Economic Commission for Europe**Inland Transport Committee****World Forum for Harmonization of Vehicle Regulations****Working Party on Passive Safety****Fifty-second session**

Regulation No. 16 (Safety-belts)**Proposal for Supplement 3 to the 06 series of amendments****Submitted by the expert from the European Association of Automobile Suppliers ***

The text reproduced below was prepared by the expert from the European Association of Automobile Suppliers (CLEPA) to amend requirements on emergency locking retractors. It is based on document without a symbol (GRSP-51-09) distributed during the fifty-first session of the Working Party on Passive Safety (GRSP) (see ECE/TRANS/WP.29/GRSP/51, para. 23). The modifications to the current text of the UN Regulation are marked in bold for new or strikethrough for deleted characters.

Diagram 1

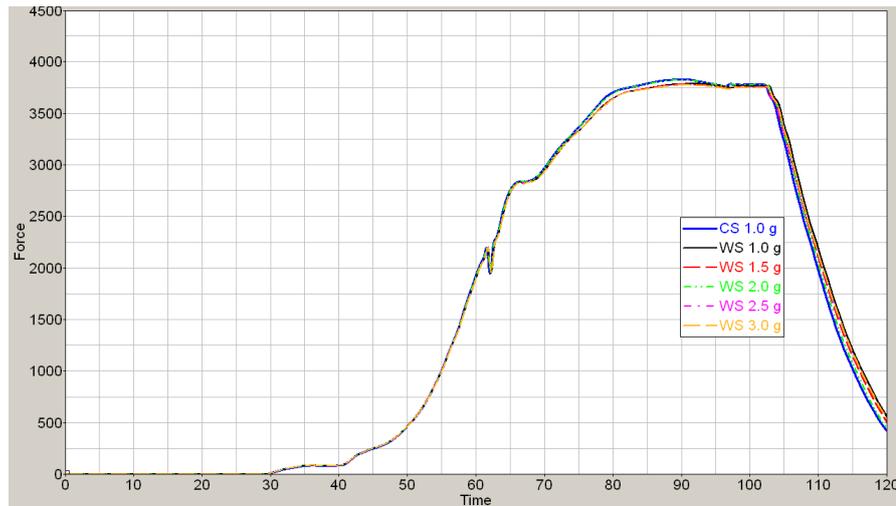
10. Vehicle sensitivity or strap sensitivity are switched off each to understand its solely influence to the belt forces. The seen onset of shoulder belt force shows no difference due to different chosen levels of strap sensitivities (WS). The diagram incorporates additionally for reference purpose the upper shoulder belt force with a vehicle sensitivity of 1.0 g (CS).

Diagram 2

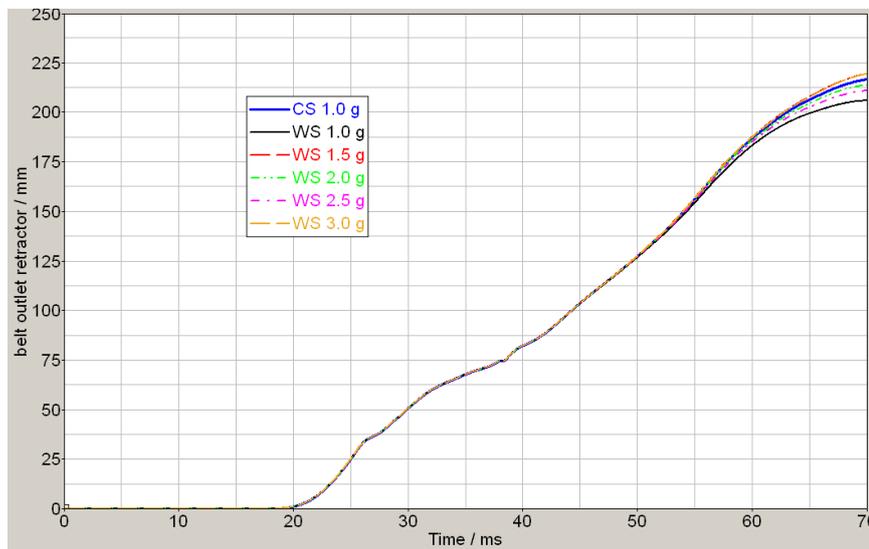
11. The consequent appearing belt movement analysed above the retractor housing, which represents the belt spending for the occupant kinematics and finally maximum forward displacement is shown in the diagram 2. The variation visible after 55 ms is

affected by the restraint system (air bag deployment, air bag to internal parts contact, etc.). It can be demonstrated that different sensor layouts, in this case up to a webbing sensitivity of 3.0g do not show any evidence for a change in the occupant kinematics.

Diagram 3

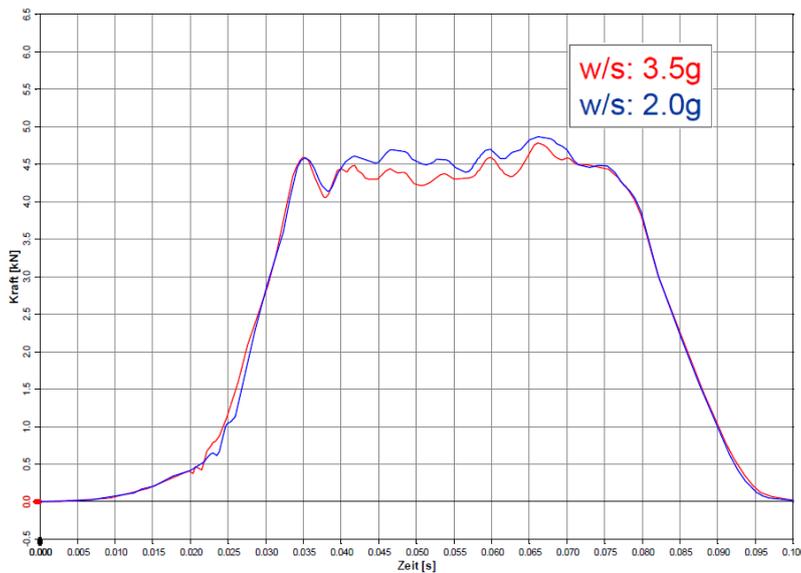
13. Diagram 3 shows the shoulder belt forces versus time, specifically with a webbing sensitivity of 2.0g and 3.5g. There is no relevant difference visible.
